# Access Compliance Report

## Public Rights-of-Way

Intersection ID: 44417	Main Street: MARVIN_RD	Cross Street: ARDREY_KELL_RD	Location: SW
ADA ID: B0E95445DF88	Ramp Type: Directional1	Initial Pass/Fail: Fail	Overall Compliance: No
		Severity Score: 12.5

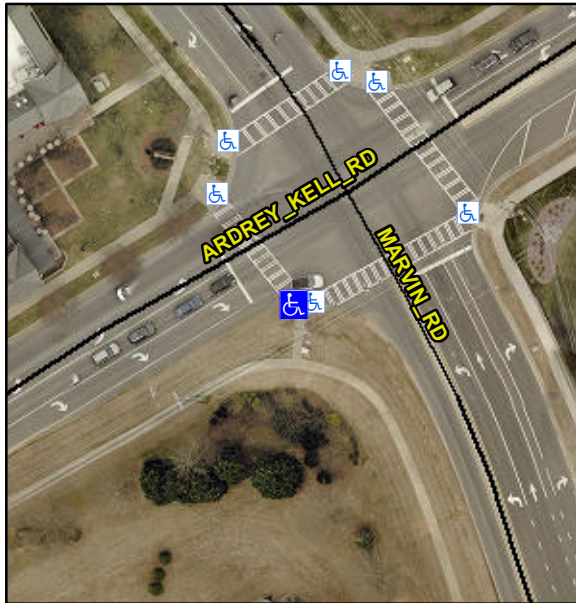
**R304.5.3**

Compliance	Description	Data	Compliance	Description	Data
N/A	Ramp Length (in)	110.0	N/A	Grade Break?	N/A
Yes	Ramp Width (in)	48.0	N/A	Grade Break Slope (%)	0.0
Yes	Ramp Slope (%)	3.6	N/A	Grade Break XSlope (%)	0.0
No	Ramp XSlope (%)	5.3			
N/A	Flare Type LT	N/A	N/A	Flare Type RT	N/A
N/A	Flare Slope LT (%)	N/A	N/A	Flare Slope RT (%)	0.0
N/A	Flare Traversable LT?	N/A	N/A	Flare Traversable RT?	N/A
N/A	Landing Length (in)	0.0	N/A	DWS Provided?	N/A
N/A	Landing Width (in)	0.0	N/A	DWS Contrast?	N/A
N/A	Landing Slope (%)	0.0	N/A	DWS Length (in)	N/A
N/A	Landing X Slope (%)	0.0	N/A	DWS Full Width?	N/A
N/A	Landing Curb? (Y/N)	N/A	N/A	DWS Offset LT (in)	N/A
N/A	Shared Landing?	N/A	N/A	DWS Offset RT (in)	N/A
N/A	Gutter Ponding?	0.0	N/A	Gutter Slope (%)	N/A
N/A	Gutter Lip Ht (in)	0.0	N/A	Gutter X Slope (%)	N/A
N/A	Painted X Walk1?	Yes		Road Slope (%)	2.3
	X Walk 1 Direction	To NW		Road X Slope (%)	3.4
	X Walk 1 Width (in)	110.0		Clear Space?	N/A

**Remove & Replace Entire Ramp.**
